Access Compliance Report

Public Rights-of-Way

Intersection ID: 44950	Main Street: WEAVERS_GLENN_PL	Cross Street: OLDCORN_LN	Location: W
ADA ID: B4DEFF7033DB	Ramp Type: Perp	Initial Pass/Fail: Fail	Overall Compliance: No
Severity Score: 21.25			
Codes/Mitigation Info/Possible Solution		Field Measurements/Component Compliance

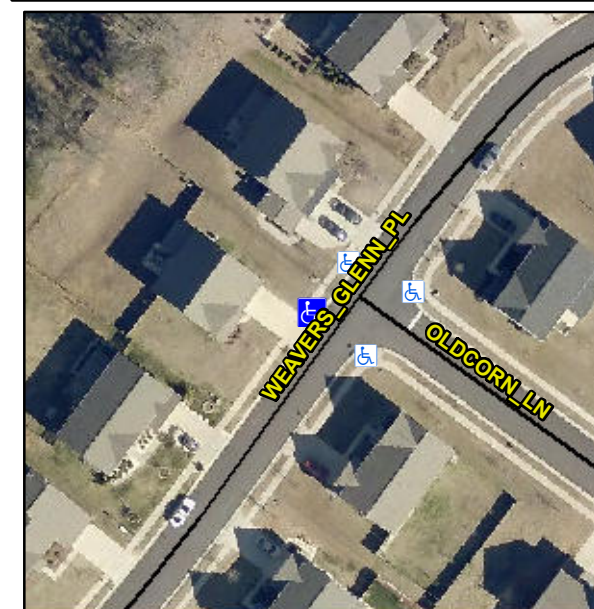
Not Found, R304.5.1, R304.2.2

Compliance	Description	Data	Compliance	Description	Data
N/A	Ramp Length (in)	47.0	No	Ramp Slope (%)	9.6
No	Ramp Width (in)	47.0	Yes	Ramp XSlope (%)	1.5
N/A	Flare Type LT	N/A	N/A	Flare Type RT	N/A
N/A	Flare Slope LT (%)	N/A	N/A	Flare Slope RT (%)	N/A
N/A	Flare Traversable LT?	N/A	N/A	Flare Traversable RT?	N/A
N/A	Landing Length (in)	N/A	N/A	DWS Provided?	N/A
N/A	Landing Width (in)	N/A	N/A	DWS Contrast?	N/A
N/A	Landing Slope (%)	N/A	N/A	DWS Length (in)	N/A
N/A	Landing X Slope (%)	N/A	N/A	DWS Full Width?	N/A
N/A	Landing Curb? (Y/N)	N/A	N/A	DWS Offset (in)	N/A
N/A	Shared Landing?	N/A			
N/A	Gutter Ponding?	N/A	N/A	Gutter Slope (%)	N/A
N/A	Gutter Lip Ht (in)	N/A	N/A	Gutter X Slope (%)	N/A
N/A	Painted X Walk1?	No	N/A	Painted X Walk2?	N/A
	X Walk 1 Direction	To SE		X Walk 2 Direction	N/A
N/A	X Walk 1 Width (in)	N/A	N/A	X Walk 2 Width (in)	N/A
	X Walk 1 Slope (%)	5.0		X Walk 2 Slope (%)	N/A
	X Walk 1 X Slope (%)	1.1		X Walk 2 X Slope (%)	N/A

Remove & Replace Entire Ramp.
